**Original Calcs Updated per Questions 1 and 2 from 05 August 2019**

**Title: Mat Slab Foundation One-Way Shear Capacity and Punching Shear**

PROJECT NAME: 301 Mission Street Perimeter Pile Upgrade

SUBJECT: Supplement No. 116

Seismic Envelope for Strips 18 - 29

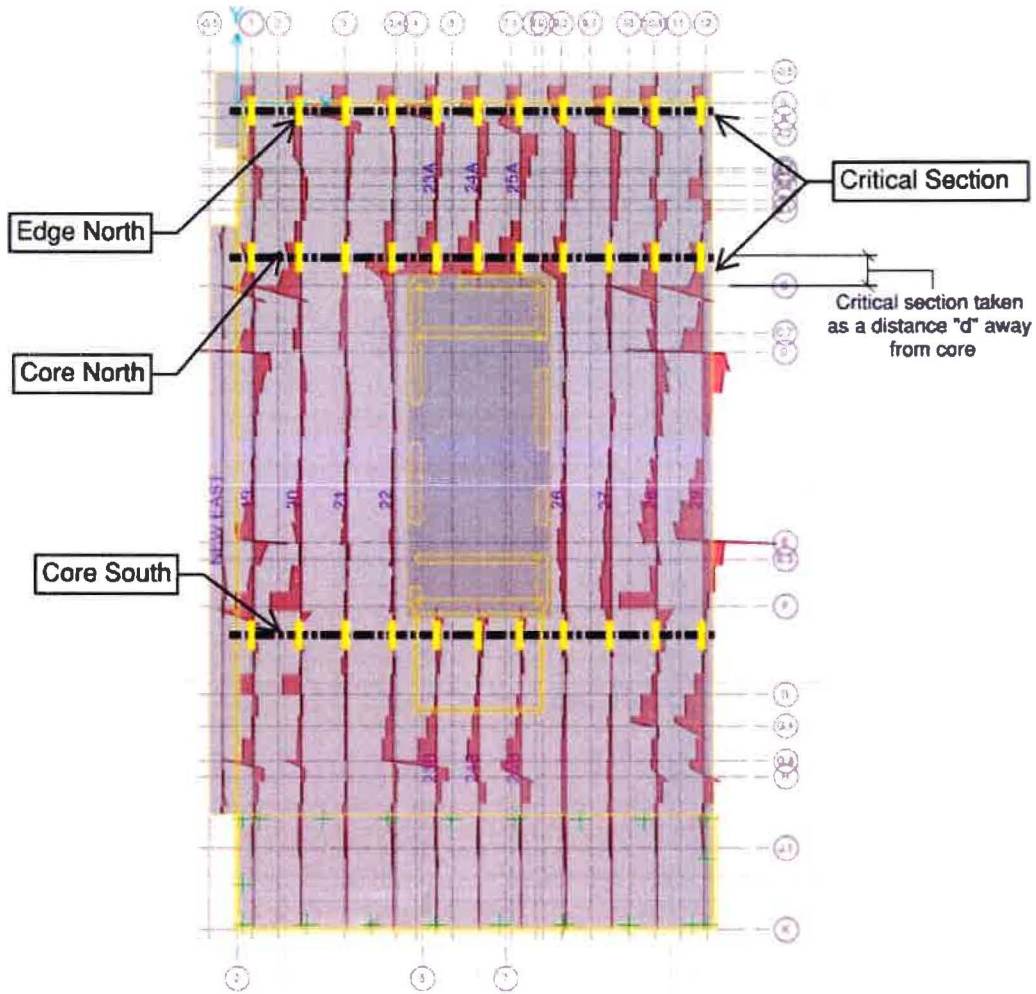
*Please justify the DCR acceptance criteria. The reported values of DCR up to 2.28 (pages 8 and 10 of supplement 116) are larger than what one would consider "somewhat higher" than 1.0. Related to this, please (1) provide a breakdown of the shear loads (D, L, E and J) and the design strengths for each strip, and (2) how the retrofit will increase the shear and flexural demands in the most critical portions of the mat (i.e. provide a side-by-side comparison of demands with and without the retrofit).. Also, (4) confirm whether the table of DCRs on pg. 8 is for the 'north' strips, since the headings in the left column refer to "west" strips, and (5) that the reference to "new east" in the figure on page 3 is a typo (seem it should be 'new west')*

Note: Strips 21, 23A and 24A have a column within d from the north edge of the mat. Maximum shears are taken at d away from those columns.

**Model with reduced membrane property modifiers  
Strip Shear Demand due to Dead + Live Loads**

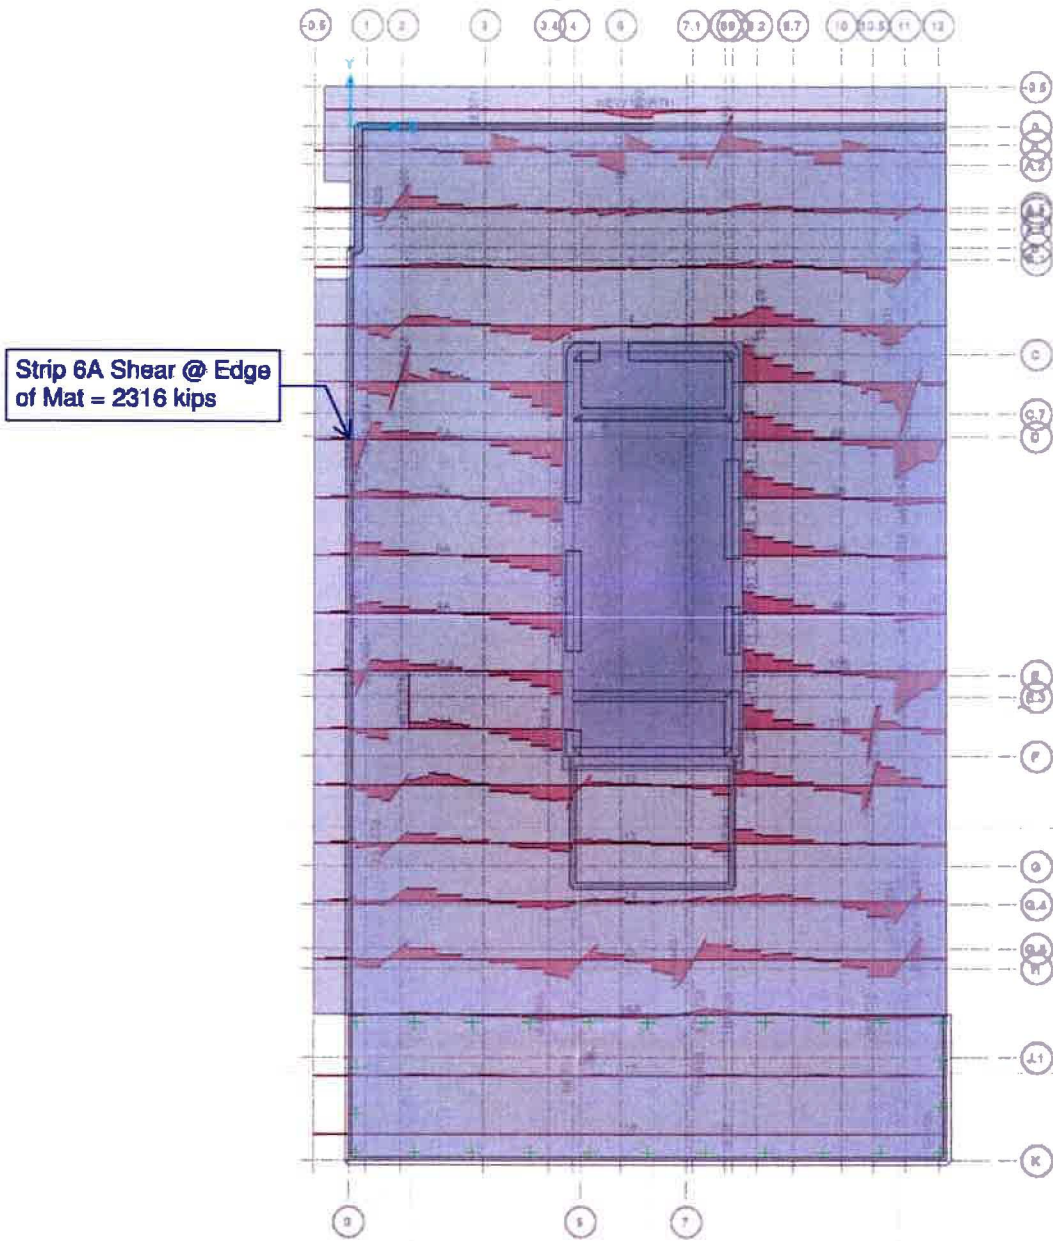
*Please confirm (1) that the calculated shears at the ed of the mat are consistent with the assumed load transfer into the new piles and (2) that the existing mat and the transfer into the mat extension can resist the induced shears. [Note - we assume that the third column on pg. 17 of supplement 16 should be labeled as "core south" rather than "core west"].*

1. Our prior calculations reported shears at the edge of the mat from a SAFE model which includes the perimeter basement walls and ground level slab. Additionally, it includes the mat extension which is present in all load cases including not only jacking but also dead and live loads. We studied load transfer from the new and existing piles into the strips of the mat extension and found that the perimeter basement walls (modeled linear elastic) acted as a composite cross section with the ground level slab, the existing mat, and the mat extension. These walls caused a major portion of the mat edge shears reported in our previous calculations. We reviewed the vertical forces exerted by these walls on each of the mat strips and found that some of those forces exceeded the tensile capacity of the vertical bars in the wall in these areas. We then recalibrated a stiffness modifier of 0.2 on the perimeter basement walls to limit the amount of this force to the yield capacity of the wall. We believe this results in more realistic estimates of the mat strip shears along the mat perimeter.

We compare the shear at the edge of the mat with the mat extension and the walls removed. The walls provided significant ability to transfer shear load along the edge of the mat. Based on this study, we assigned membrane property modifiers of 0.2 for the foundation walls.
